MEMORANDUM FOR: J. C. Stepp, Chief, Geosciences Branch, DSE

SUBJECT: EXAMINATION OF NEW TRENCHES EXPOSING THE FAULT AT NINE
MILE POINT AND RECENTLY DISCOVERED FAULTS IN THE INTAKE
TUNNEL SHAFT

50-410

Fig. 1 Location of faults, trenches, test borings, and site of overcore stress measurements

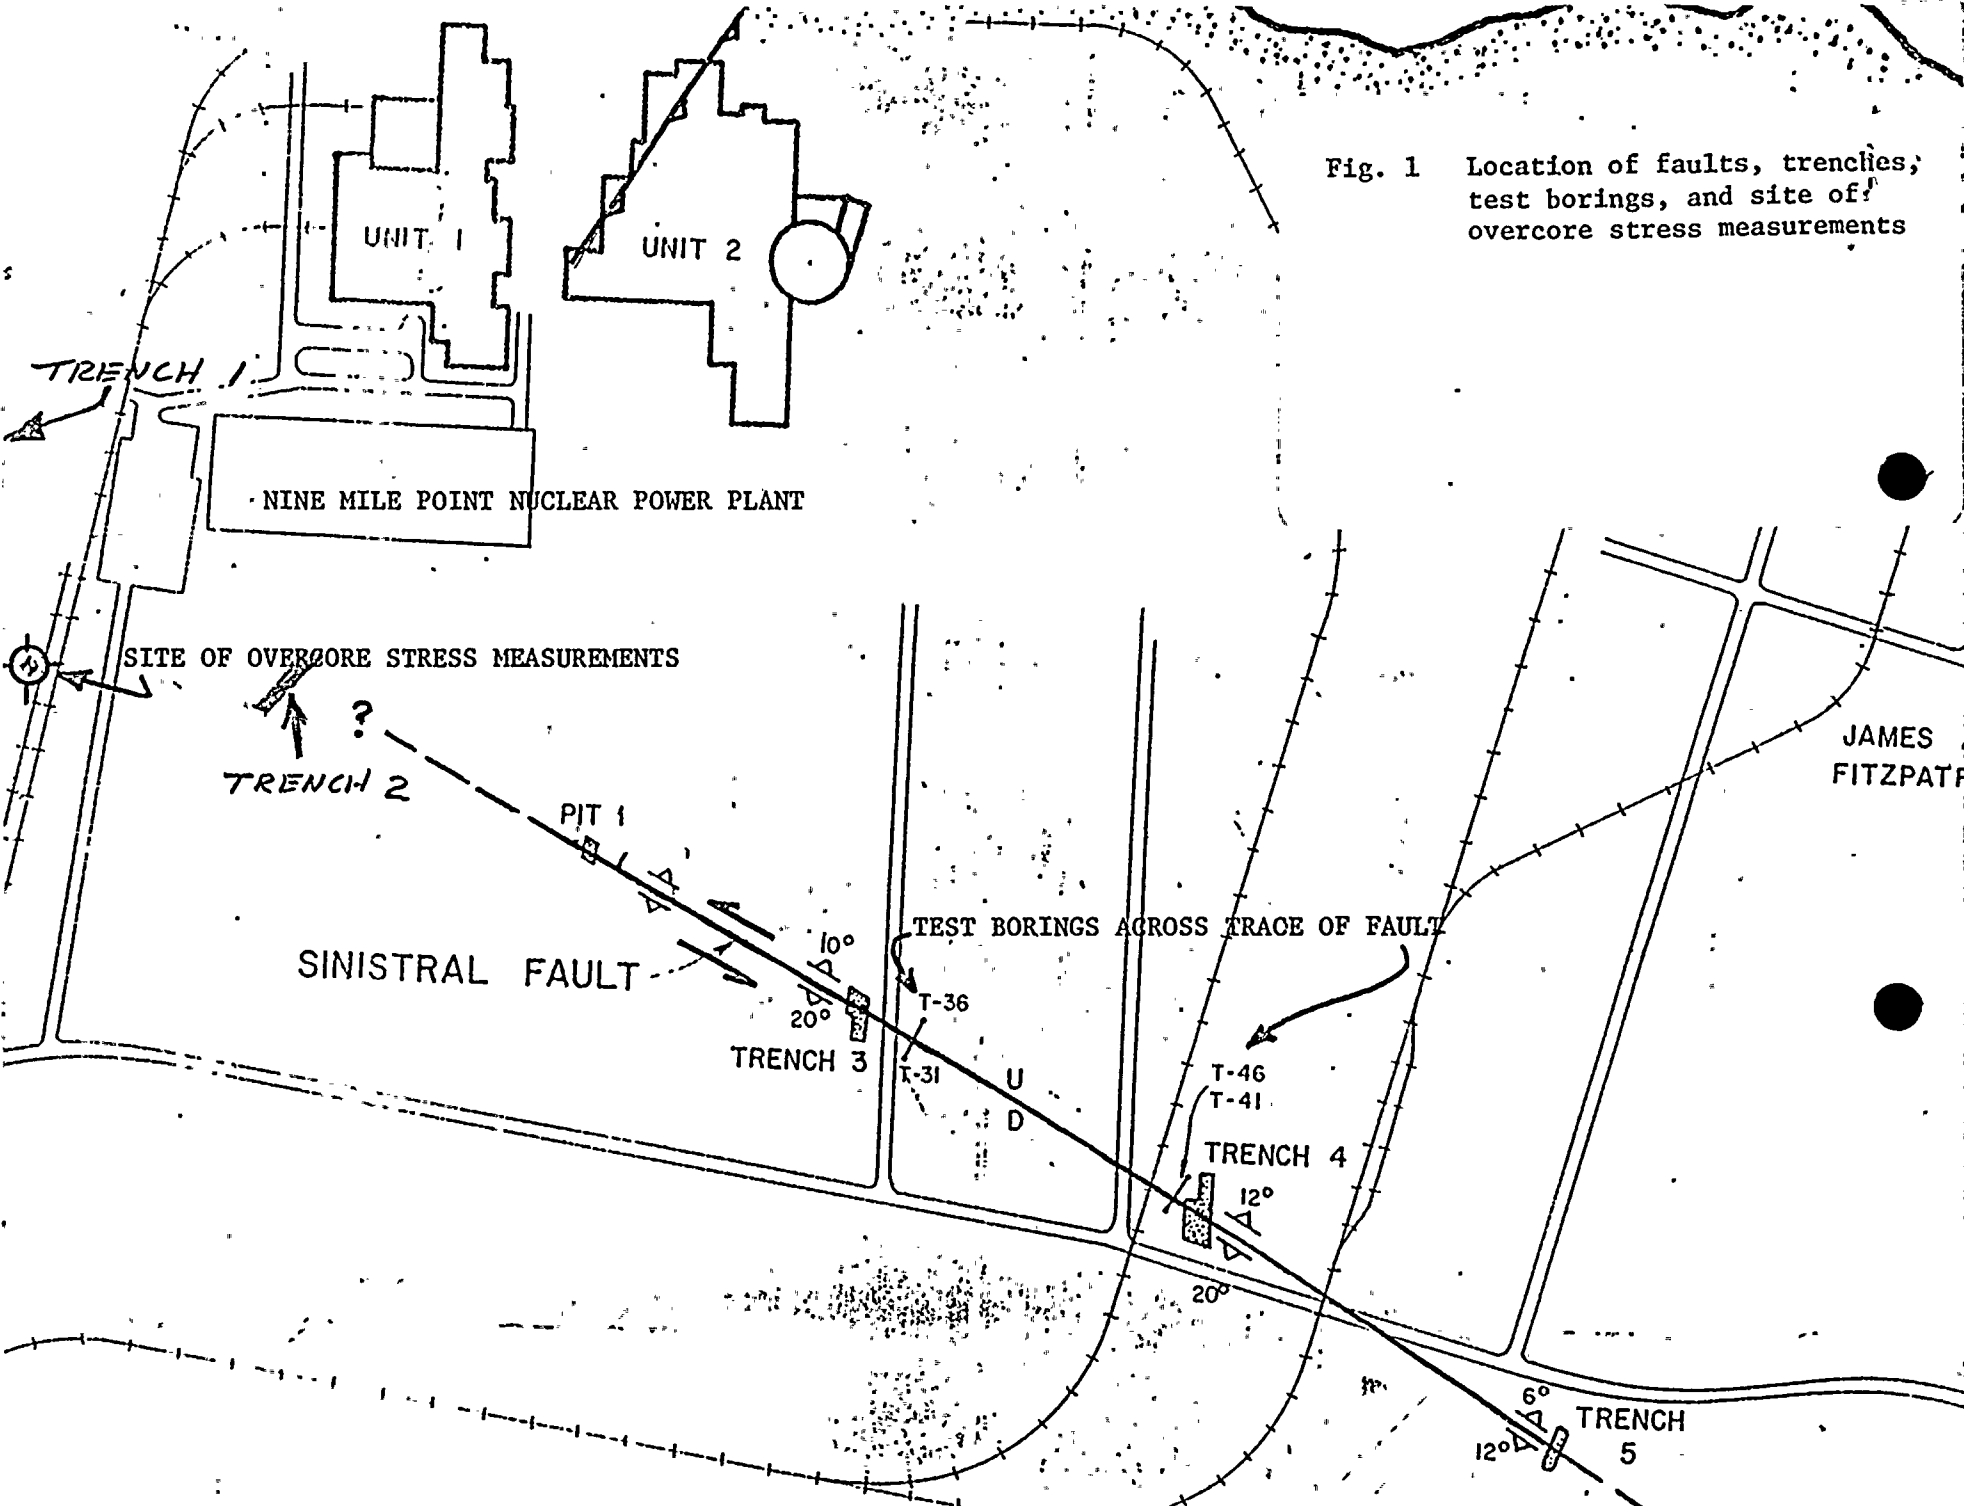
The Applicant had completed one new trench (trench 5) since our last visit in December, 1976 (see fig. 1 for locations of features mentioned). Also completed were geomorphic studies, initial borings along two north-south lines across the fault and a series of in situ stress measurements in one borehole.

Drilling of 2 north-south lines of borings is underway, one immediately east of Trench 3, and the other just west of Trench 4. Those borings that have been completed to date indicate that the bedding, which is turned up on both sides of the fault, becomes flatter with depth, until they appear to be nearly horizontal, between 100 and 200 feet, and thus consistent with the regional dip.

We examined 3 low angle thrust faults near the bottom of the entrance shaft to the cooling water intake tunnel. The faults strike northeast and dip toward the southeast. By noting similarities to other similar structures in the site region, the Applicant attributes their origin to Paleozoic deformation.

The Applicant informed us that he would like to begin filling trenches 1, 2 and 3 in seven to ten days. The bedrock slot in trench 3 would be left open as well as trenches 4 and 5. We stated that we had no objection to filling trenches 1, 2 and 3 as long as they were mapped and photographed in detail, and that all the features observed in 1, 2 and 3 were preserved in the other trenches. They do not plan to determine the southeastern extent of the fault because the apparent superficial nature of the latest movement on the fault rules out the possibility of a large earthquake occurring on it. The NRC will not make a decision on this matter until additional data is available. Future submittals planned by Niagara Mohawk include: a letter briefly describing the thrust faults in the intake tunnel shaft and updating the investigations of the vertical fault through the cooling tower area, and revising the letter of 24 February, 1977 to reflect any new information that would change interpretations made at that time. A final report of all geologic features on the site and the results of all investigations will be available in 4 or 5 months.
